# CONDITIONS SUITE V2 (mark-up)

*Arataki Project*

*CDL Land New Zealand Limited*

**Substantive Application  
Fast-Track Approvals Act 2024  
20 November 2025**

<i>Rear Sites on Jointly Owned Access Lots Consent Notice (Lots 19, 20, 71, 72, 121, and 152)</i>

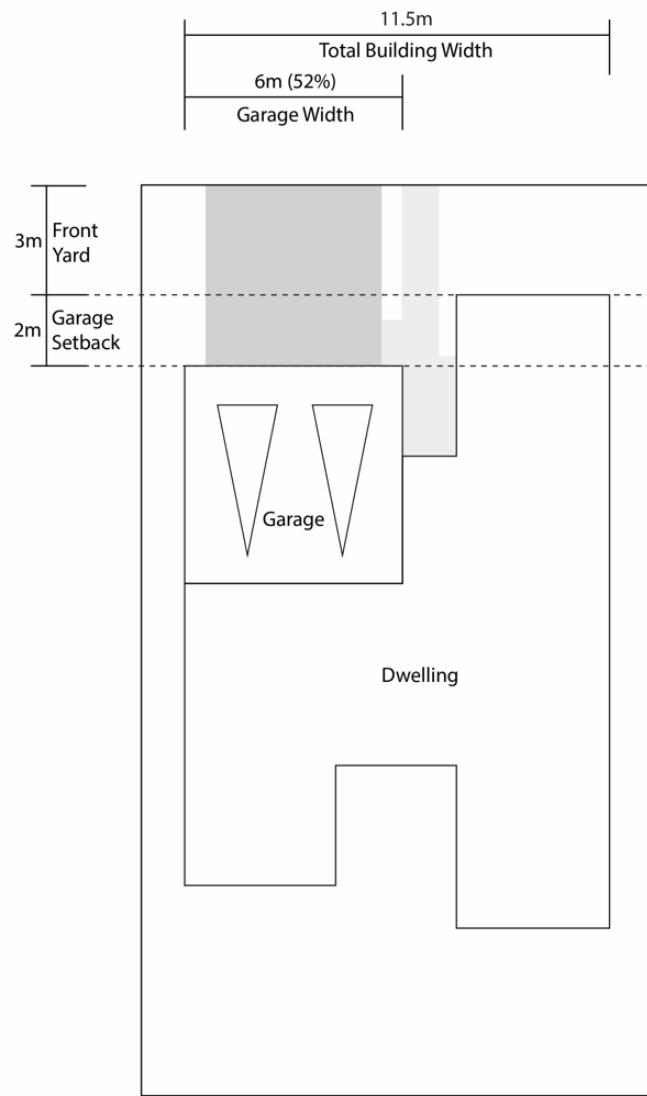
No.	Condition	Invited Party Feedback	CDL Commentary on Changes
68.	<p><b>On-site Vehicle Manoeuvring (Rear Lots)</b> (<a href="#">Lots 19, 20, 71, 72, 121, and 152</a>)</p> <p>The consent holder must register with the Registrar-General of Land a consent notice under Section 221 of the RMA, against the computer registers (certificates of title) for Lots 19, 20, 71, 72, 121, and 152. The consent notice must record that the following condition is to be complied with on a continuing basis:</p> <p><i>"On-site vehicle manoeuvring: At the time of development, Lots 19, 20, 71, 72, 121, and 152 the lot shall be designed and constructed to provide on-site vehicle manoeuvring that enables forward entry and forward exit movements onto the adjoining jointly owned access lot. This is to avoid extended reversing movements onto public roads and ensure safe and efficient access for rear lots."</i></p>		<p><b>Consequential amendment:</b> Created new title block above in line with drafting approach to conditions. Referenced affected lots directly within consent notice to ensure clarity as to what lots this requirement applies to.</p>

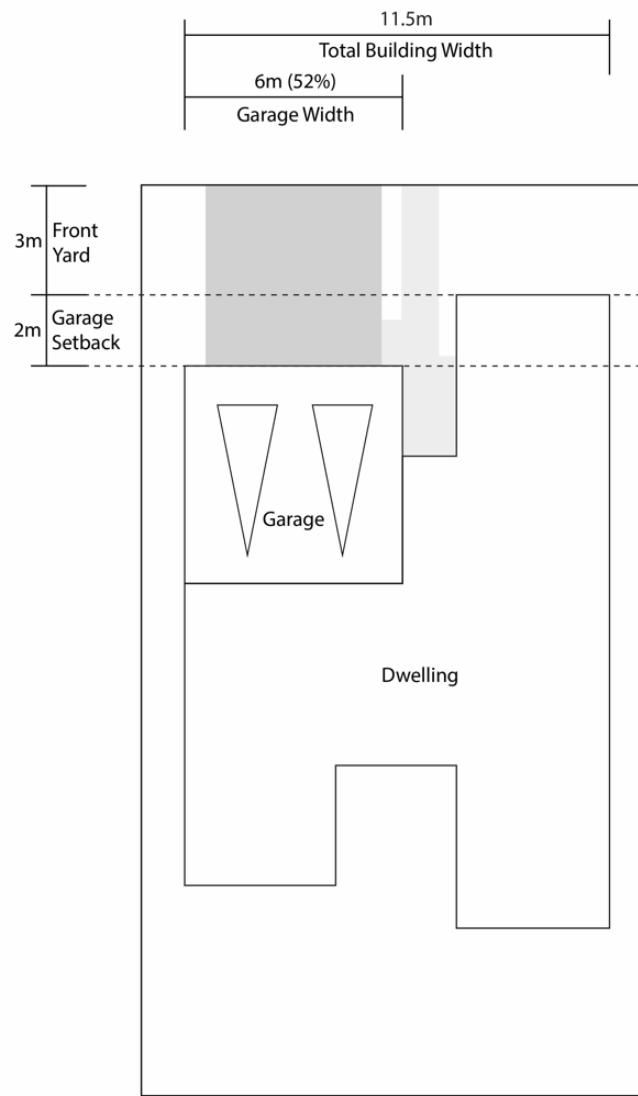
Also increased size of text and added extra description for context.

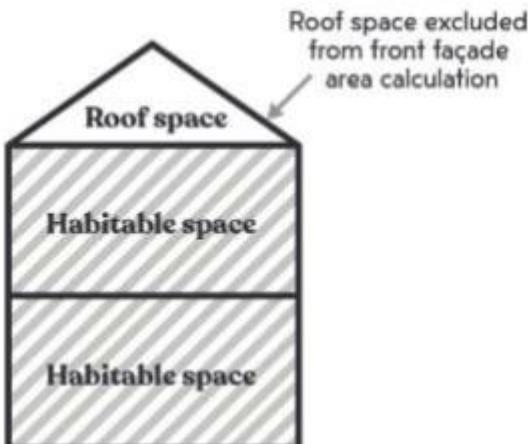
No.	Condition	Invited Party Feedback	CDL Commentary on Changes
68H.	<p><b><u>Glazing &amp; Street Connection (Lot Type 2)</u></b></p> <p><u>The consent holder must register with the Registrar-General of Land a consent notice under Section 221 of the RMA, against the computer registers (certificates of title) for Lots 22-26, 34-37, 45-47, 74-76, 78-81, 103-106, and 109-119. The consent notice must record that the following condition is to be complied with on a continuing basis:</u></p> <p><u><i>“Building Restrictions – Glazing &amp; Street Connection:</i></u></p> <p class="list-item-l1">(a) <u><i>Any residential unit facing the front boundary or legal access must have a minimum of 10% of the façade facing the front boundary in glazing. This can be windows or doors (excluding garage doors). As shown in the diagram below, the roof space is excluded from the front façade area calculation.</i></u></p> <p class="list-item-l1">(b) <u><i>Any residential unit facing the front boundary must incorporate at ground level facing the front boundary or legal access a front door and main pedestrian entrance that is visible and accessible from the front boundary or legal access.”</i></u></p>	<p><b>HDC Feedback:</b> Council concerned with bespoke framework outside of the HDP provisions and potential development situations resulting in onerous need for consent notice variations. Have been dealing with applicant directly about a preferred consent notice-based approach that provides a clear, enforceable framework that reflects the HDP while enabling some of the bespoke conditions desired by applicant.</p>	<p><b>Accept:</b> Remove RDF framework approach and impose new consent notices to address rural zoning.</p> <p>A bespoke glazing and street-interface solution is sought, with a 10% glazing outcome rather than the 20% Medium Density Residential Zone standard. A 20% requirement can force poor façade composition on smaller dwellings by limiting window placement that does not align with internal layouts or privacy needs. The 10% outcome enables a balanced and context-specific design response.</p>
